**PM8315  
TEMUX**

**DATA SHEET ERRATA**

**March, 2001**

**Figure 1 Recommended System and Board Clocking**

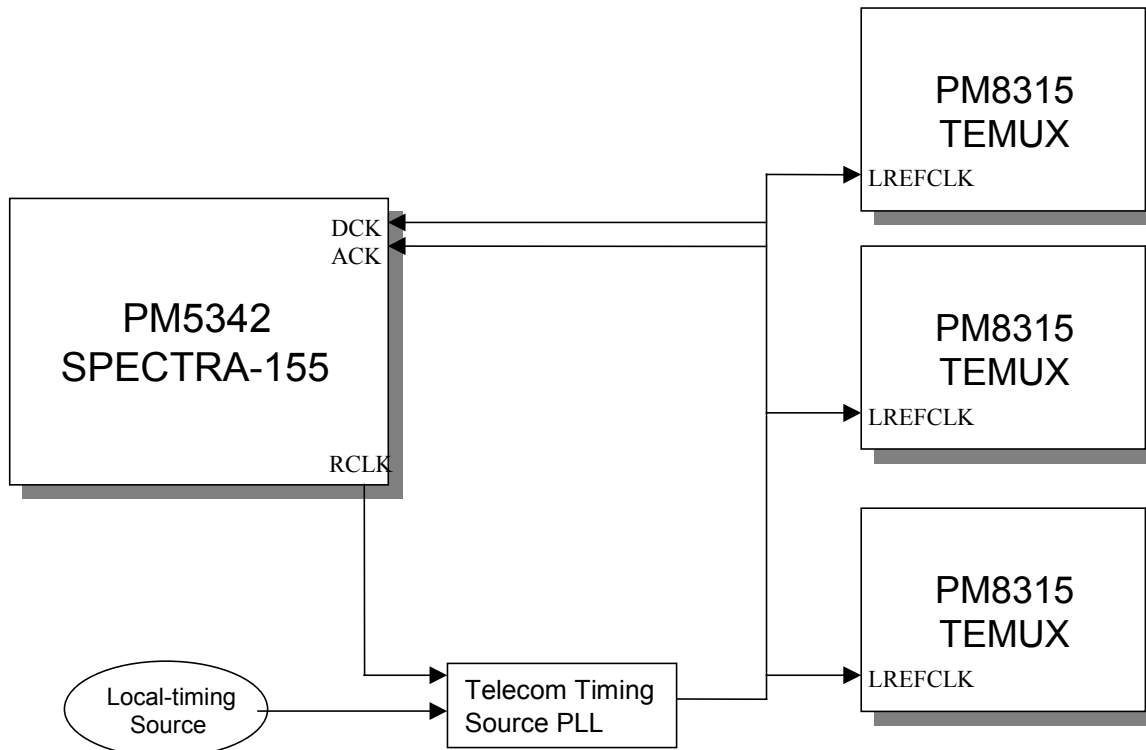
Due to an issue in the TEMUX demapper there is potential for a loss of data bits, and resulting loss of frame on one or more T1 or E1 links. The effects of this issue are only manifested in the specific case when the demapper receives VT level pointer movements in combination with high-density bit stuffing. This issue will only effect VT/TU mapping mode and does not apply to any DS3 applications. Revision G of the TEMUX has been modified so that demapper errors in VT/TU mapping applications will not be possible.

There is no possibility of errors due to this demapper issue if pointer movements are eliminated. Figure 1 shows the recommended system and board clock configuration to minimize pointer movements. This configuration will not eliminate the potential for VT-level pointer movements already in the receive stream.

The TEMUX demapper issue is aggravated by high density bit stuffing. High density bit stuffing can appear when the TEMUX mapper is mapping a synchronous tributary, where the transmit T1/E1 clock (SREFCLK, CTCLK, CECLK or CMV8MCLK) is frequency locked to the transmit telecom bus clock (LREFCLK). This issue may also be manifested when the mapped T1/E1 clock has a minute PPM offset relative to the SONET/SDH virtual container **and** there are VT level pointer movements. The error condition is such that the lower the frequency of pointer movements the smaller the permissible PPM offset of the T1/E1 clocks

for error-free operation. VT level pointer movements are required for this error case; if pointer movements are minimized with the configuration as shown in Figure 1, the potential for errors will be greatly reduced.

The required clocking configuration must have both the telecombuss looptimed as well as the SPECTRA. To looptime the telecombuss the LREFCLK input of the TEMUX must be sourced from the RCLK output of the SPECTRA-155. RCLK also needs to be connected to DCK(D15) and ACK(C12) of the SPECTRA so the entire Telecombuss remains synchronous. To looptime the SPECTRA to prevent the generation of outgoing pointer movements, the LTE bit of register 00H must be set. An alternative to looptiming SPECTRA is to input the network clock into TRCLK on the SPECTRA and the Telecom Timing Source PLL.

Note: RCLK is pin L17 of the SPECTRA and is enabled by setting the RCLKEN bit in register 80H. LREFCLK is pin W12 of the TEMUX.

**5.8. TEMUX Mechanical Drawing**

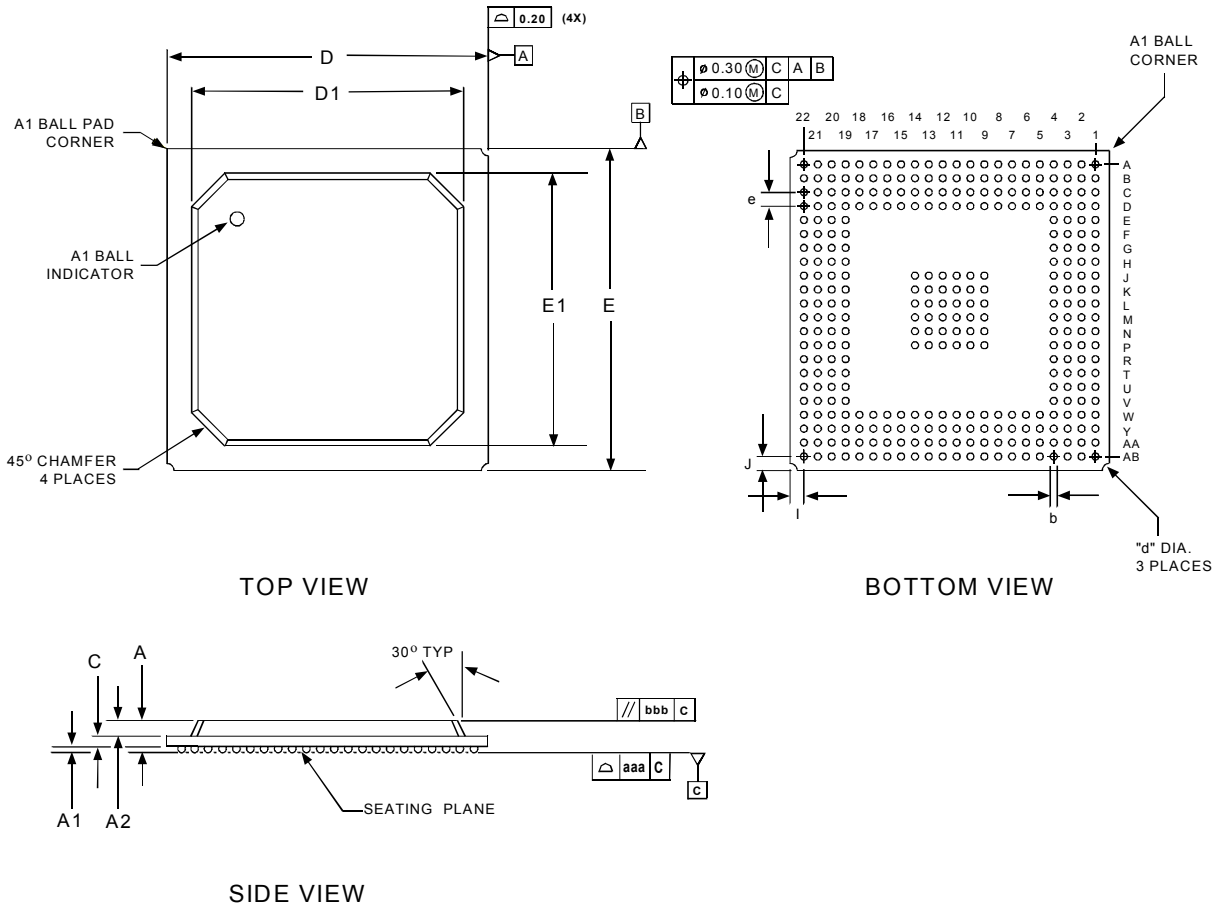
The height dimensions listed in the Mechanical Information section of the datasheet are incorrect. The dimension in error is the thickness of the package. The following figure contains the correct dimensions.

PACKAGE TYPE : 324 PLASTIC BALL GRID ARRAY - PBGA																	
BODY SIZE : 23 x 23 x 2.28 MM (4 layer)																	
Dim.	A (2 layer)	A (4 layer)	A1	A2	D	D1	C (2 layer)	C (4 layer)	E	E1	I	J	b	d	e	aaa	bbb
Min.	1.82	2.07	0.40	1.12	-	19.00	0.30	0.55	-	19.00	-	-	0.50	-	-	-	-
Nom.	2.03	2.28	0.50	1.17	23.00	19.50	0.36	0.61	23.00	19.50	1.00	1.00	0.63	1.00	1.00	-	-
Max.	2.22	2.49	0.60	1.22	-	20.20	0.40	0.67	-	20.20	-	-	0.70	-	-	0.15	0.35
